BOLLETTINO TECNICO

N° **139-311**

**SUBFLOOR FRAME STA2105 RETROMODIFICATION P/N 3G5306P47211,
INSTALLATION OF.**

To reinforce the Tail Rotor (TR) pedals support frame, performing interim repetitive inspections until implementation of the retromodification.

Figure 21

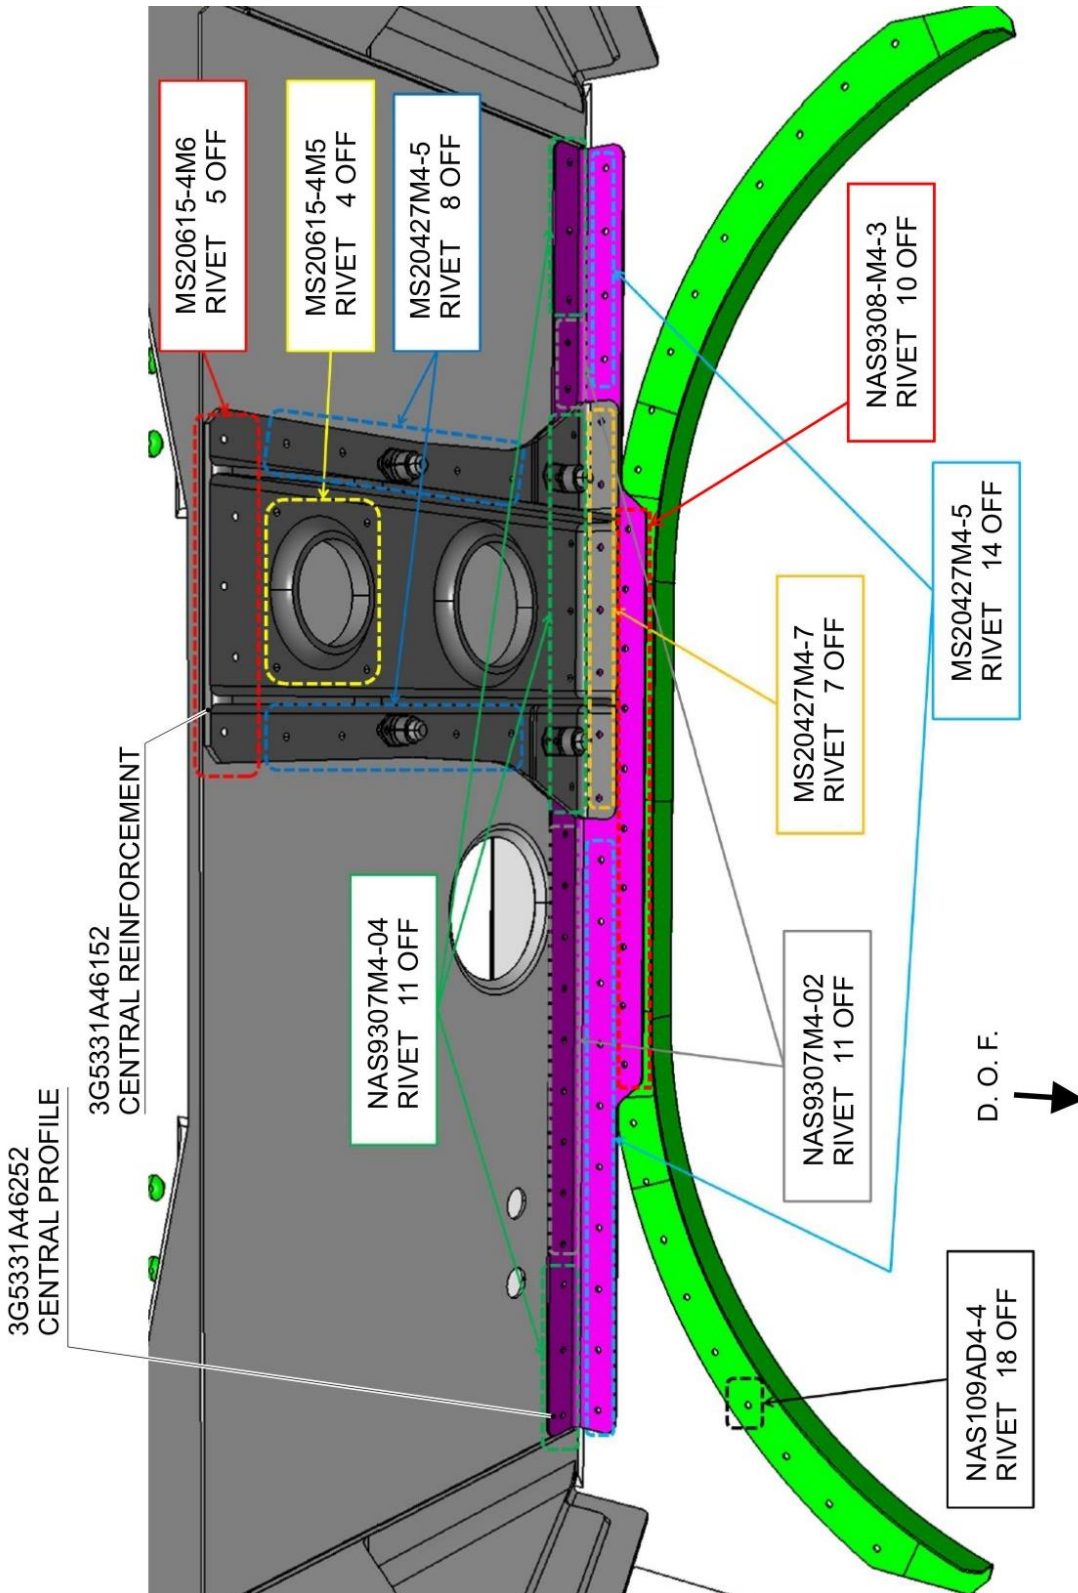
7.6.8. Fix central profile P/N 3G5331A46252 to the middle frame (STA2105) with rivets P/N NAS9307M-4-04 and P/N NAS9307M-4-02 according to figures 18 and 21.

- 7.6.9. Fix reinforcement P/N 3G5331A46152 to the middle frame (STA2105) and to the central profile with five rivets P/N MS20615-4M6, four rivets P/N MS20615-4M5, eight rivets P/N MS20427M4-5, seven rivets P/N MS20427M4-7 and five rivets P/N NAS9307M-4-04, using existing holes according to figures 18, 19 and 21.
- 7.7. With reference to figure 18, install self-locking nuts on the central reinforcement as follows:
- 7.7.1. Drill 6.50-6.65 mm diameter holes on central reinforcement according to existing holes on the longeron.

Figure 22

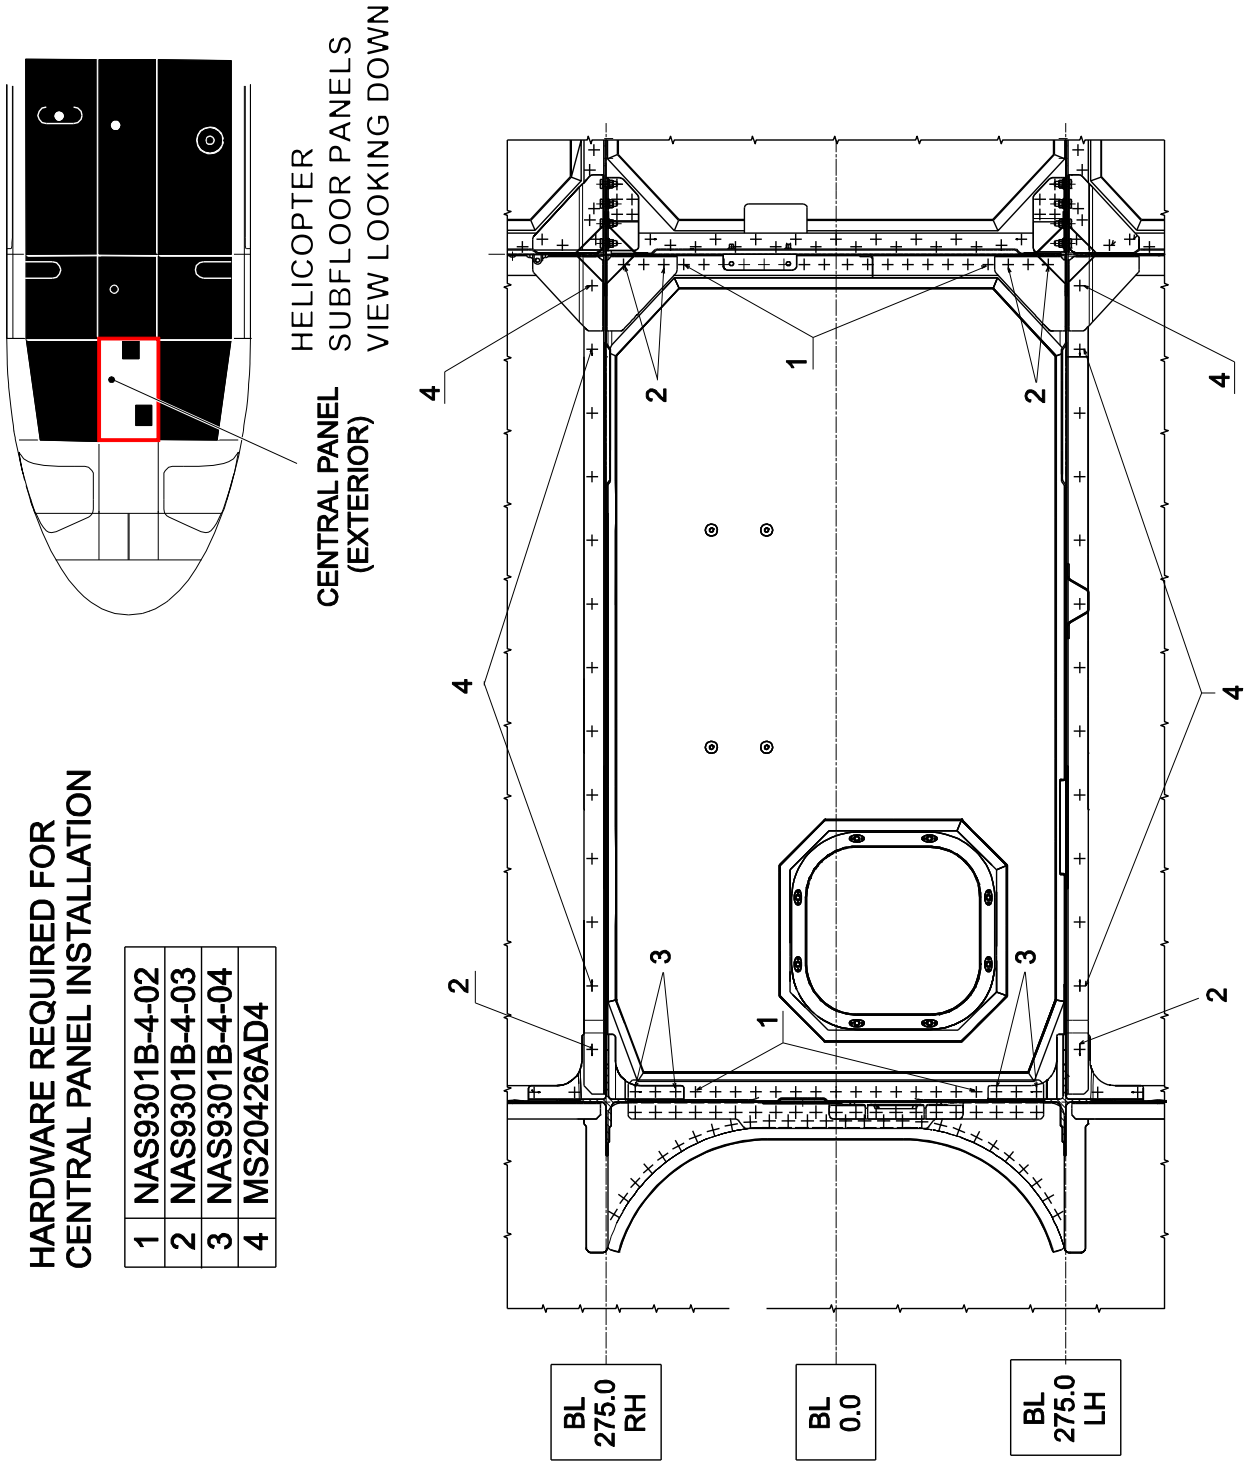
- ✓ the pilot pedal set. Refer to AMP, see DM n° 39-A-67-21-01-00A-720A-A.
 - ✓ the copilot pedal set. Refer to AMP, see DM n° 39-A-67-21-02-00A-720A-A.
11. Install the central panel using hardware shown in figure 22.
 12. Install other access panels, floor panels, liners and equipments removed at step 2 and step 5.
 13. With reference to figure 3, install the LH and RH nose windows as follows:
 - 13.1. Install the LH nose window (1) using twenty-seven screws (2) P/N MS27039-1-10 and four screws (4) P/N MS27039-1-9 (in the corners) with washers (3).
 - 13.2. Install the RH nose window (5) using twenty-seven screws (6) P/N MS27039-1-10 and four screws (8) P/N MS27039-1-9 (in the corners) with washers (7).
